Technical Service Bulletin

REAR DOOR WEATHERSTRIP COMES OFF

Bulletin No.: 09-018/19

2016-2018 CX-9 vehicles with VINs lower than JM3TC*****237357 (produced before June 30, 2018)

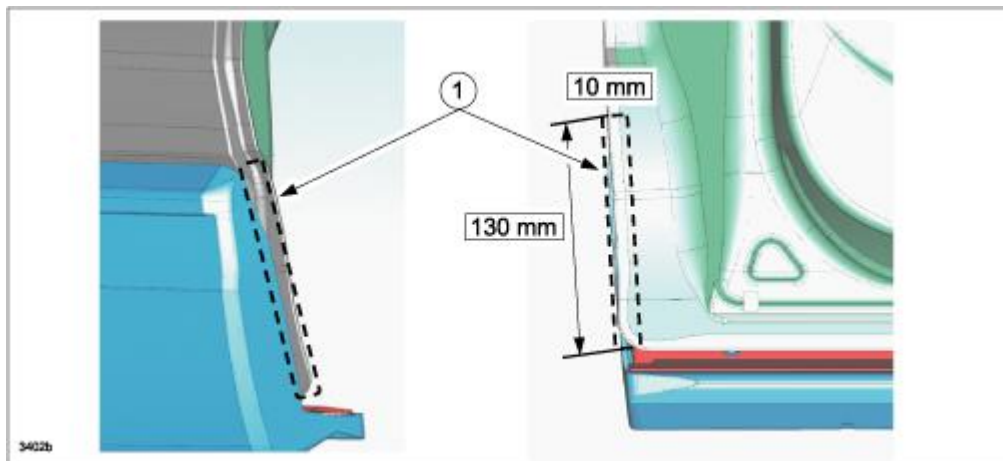
Some customers may complain that the door weatherstrip (1) comes off at the front / lower part of the rear door(s). This concern is caused by insufficient weatherstrip gripping force. To eliminate this concern, the shape of the weatherstrip has been changed.

1. Verify the customer concern.
2. Remove the affected weatherstrip from the rear door.
3. Clean and degrease the front / lower part of the rear door hemming (1) with isopropyl alcohol and a clean shop towel.

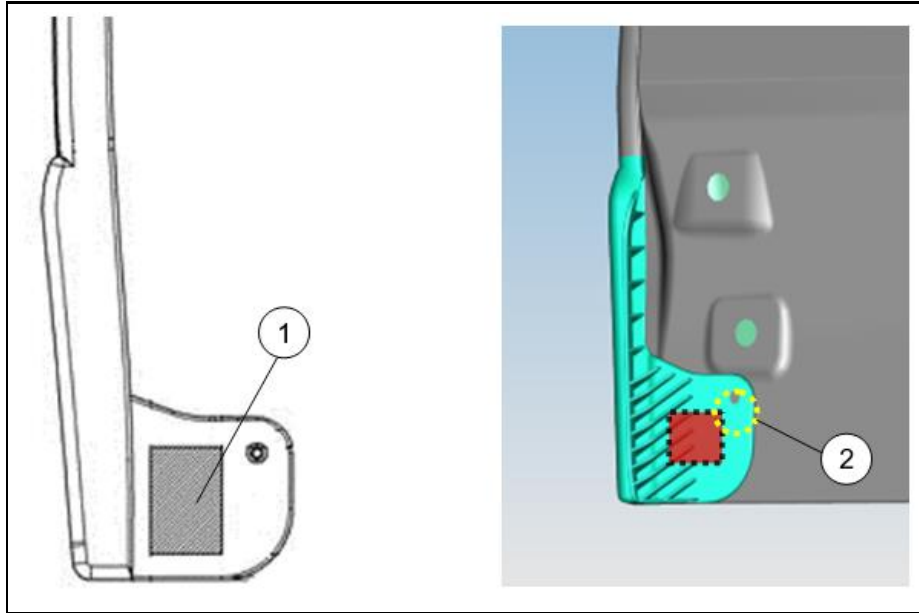
- Dual-sided adhesive tape (1) is already attached.
- Ignore hole (2), it's for the weatherstrip clip.

5. Install a new weatherstrip as shown below.

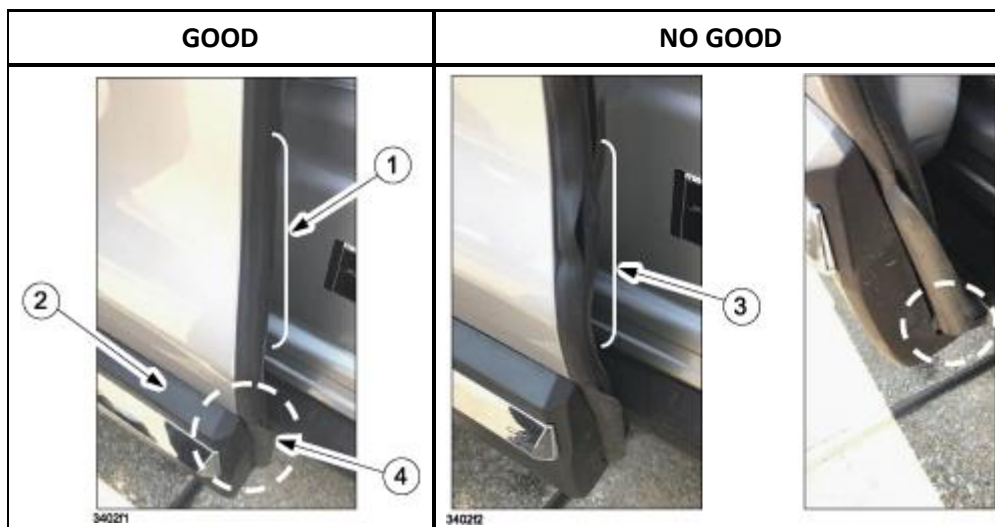
- Install the weatherstrip (1) working from the top downward so that it will not create a wave (3).
- Install the weatherstrip lip (4) under the door garnish (2).
